Memorandum

To: Anne Hersch, City of Albany
From: Christy O'Berry
Reviewed by: Jonathan L. Kramer
Date: January 4, 2012
RE: PA08-038 (AT&T Mobility)
1035 San Pablo Ave

Figure I: Existing AT&T signal coverage in the Cellular band without the proposed site, all as asserted by AT&T. (Source: AT&T Mobility).

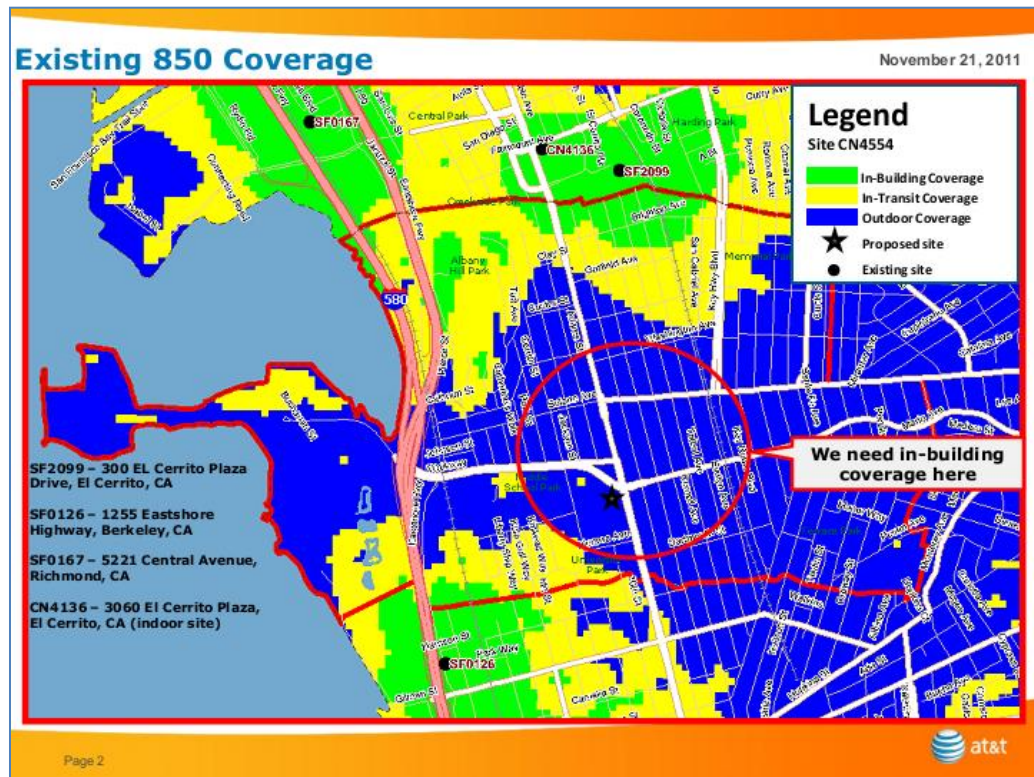
Figure I below, depicts AT&T's computer projection assertions of the existing coverage levels in only the Cellular band for the area surrounding the proposed site. The coverage map indicates that AT&T currently has "outdoor" signal level coverage, as AT&T defines that term, to the areas surrounding the proposed site.

Figure 2: Proposed AT&T signal coverage in the Cellular band with the proposed site operational, all as asserted by AT&T. (Source: AT&T Mobility).

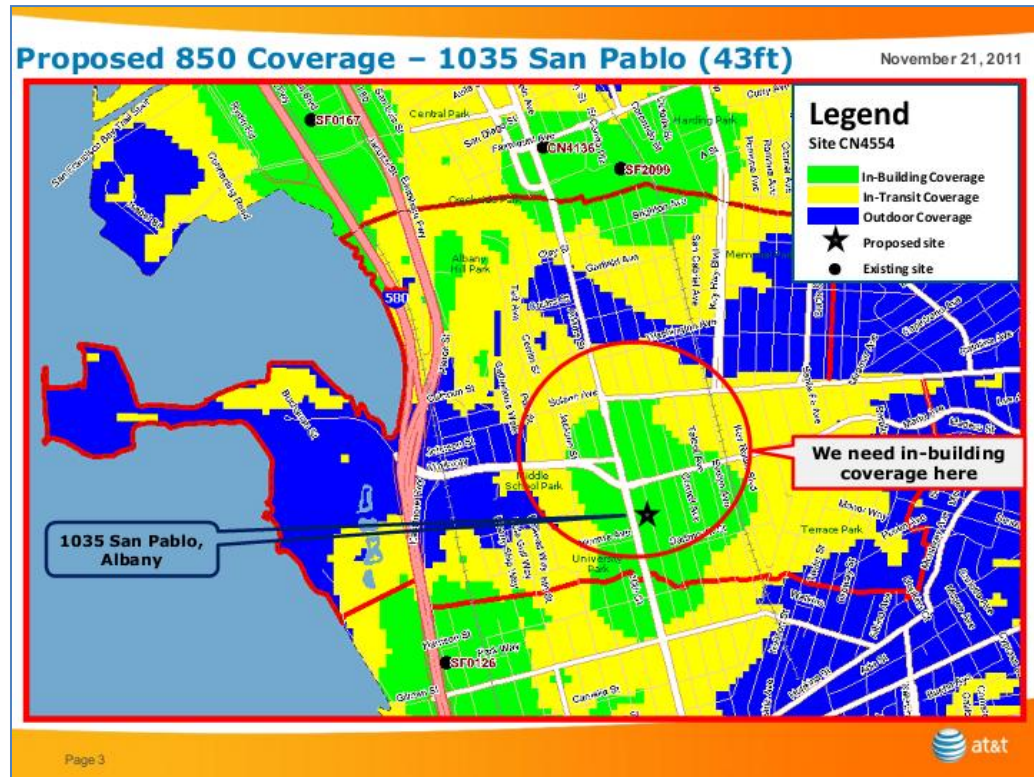
Figure 2 above, indicates that the proposed site will provide “in-building” signal coverage, as AT&T defines that term, to the area surrounding the site in the Cellular band of service, and “in-transit” (mobile) coverage beyond the “in-building” coverage area.

The coverage maps and project documentation support the proposition that AT&T is attempting to improve its service in the Cellular band to southeast Albany and indicates that AT&T has a lower grade of existing coverage in its Cellular band of service this area, whatever that grade may be.
